RE: Former Exxon RAS #7-3567/3192 Santa Rita Road, Pleasanton, California.

SUBJECT Agency Response and Addendum to Work Plan for Additional Assessment
Former Exxon Service Station 7-3567
3192 Santa Rita Road, Pleasanton, California

Subject: Fuel Leak Case No. RO0002426 and Geotracker Global ID T0600100539, Valero #3827, 3192 Santa Rita Road, Pleasanton, CA 94566

Subject: Fuel Leak Case No. RO0002426, Former Exxon Station #7-3567, 3192 Santa Rita Road, Pleasanton, CA

PROPOSED BORING LOCATIONS

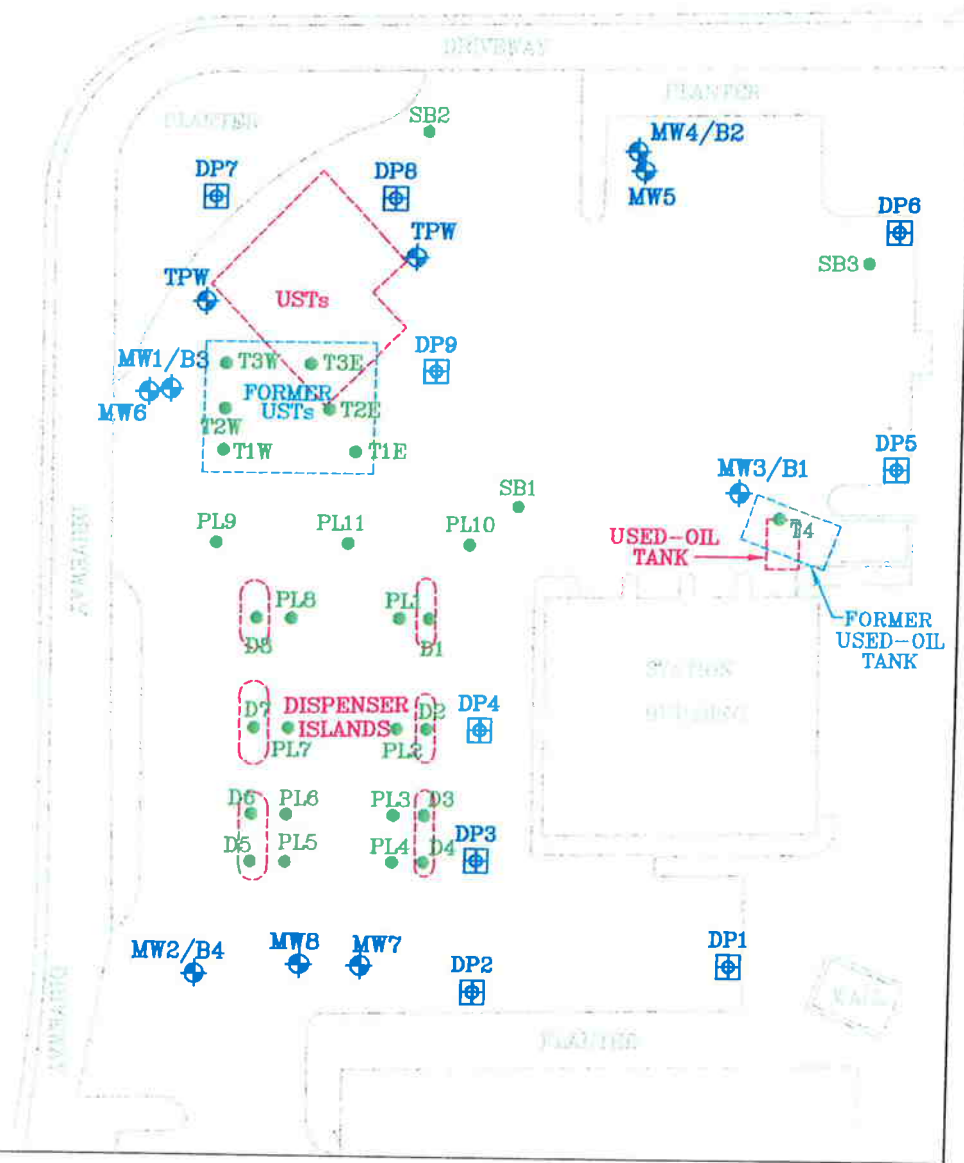
The Work Plan proposes advancing soil borings at six locations to evaluate areas downgradient from the dispensers and underground storage tanks (USTs). However, the Work Plan does not include soil and groundwater sampling in the area of the USTs as requested in ACEH's September 5, 2006 correspondence. The apparent rationale for not proposing the requested work is stated in the last two sentences of the Work Plan section entitled, "TPH Source in the Tank Pit Area," which reads, "Because Exxon Mobil has not operated the USTs at the site for seven years, sampling soil and groundwater in the vicinity of the existing UST system does not necessarily provide information relevant to Exxon Mobil's release at the site. Concerns about soil and groundwater conditions in the current UST cavity should be addressed to the current operator of the USTs." Exxon Mobil owned and operated the USTs in their current location from 1988 to 2000. Unauthorized releases occurred at the site prior to 1988 and sometime between 1988 and 1998. We are not aware of any releases that occurred after 1998; please provide any evidence you have that releases occurred after 1998. The possibility that the investigation of a known release could encounter contamination from a more recent unknown release is not a basis for not conducting site characterization. Further, all RPs are jointly and severally liable for the pollution at this site. This directive letter requests that all releases at the site be investigated. During this and all subsequent phases of work, if different RPs have contributed to the release(s), then it is the responsibility of the RPs to apportion costs for the work amongst themselves. We find no basis for Exxon Mobil to avoid investigating the tank pit source area. Therefore, Exxon Mobil is to prepare a revised Work Plan by July 6, 2007 that includes a scope of work to investigate soil and groundwater contamination in the tank pit area as requested in our previous September 5, 2006 correspondence.

1. **Proposed Scope of Work.** The Work Plan proposes advancing soil borings at six locations to evaluate areas downgradient from the dispensers and USTs. However, the Work Plan does not include soil and groundwater sampling in the area of the USTs as requested in ACEH's September 5, 2006 correspondence (attached). The apparent rationale for not proposing the requested work is stated in the last two sentences of the Work Plan section entitled, "TPH Source in the Tank Pit Area," which reads, "Because Exxon Mobil has not operated the USTs at the site for seven years, sampling soil and groundwater in the vicinity of the existing UST system does not necessarily provide information relevant to Exxon Mobil's release at the site. Concerns about soil and groundwater conditions in the current UST cavity should be addressed to the current operator of the USTs." ExxonMobil owned and operated the USTs in their current location from 1988 to 2000. Unauthorized releases occurred at the site prior to 1988 and sometime between 1988 and 1998. We are not aware of any releases that occurred after 1998; please provide any evidence you have that releases occurred after 1998. The possibility that the investigation of a known release could encounter contamination from a more recent unknown release is not a basis for not

While ERI and XOM still feel that accessing and investigating active USTs is the responsibility of the UST owner, an addendum to ERI's Work Plan, adding three additional borings (DP7 through DP9) in the vicinity of the USTs, is provided in the next section of this document.

To investigate soil and groundwater conditions in the vicinity of the existing USTs, ERI proposes three additional paired direct-push/HydroPunch® borings (DP7 through DP9) for collection of soil and groundwater samples from shallow and deep zone sediments.

Proposed soil boring locations are shown on Plate 1.
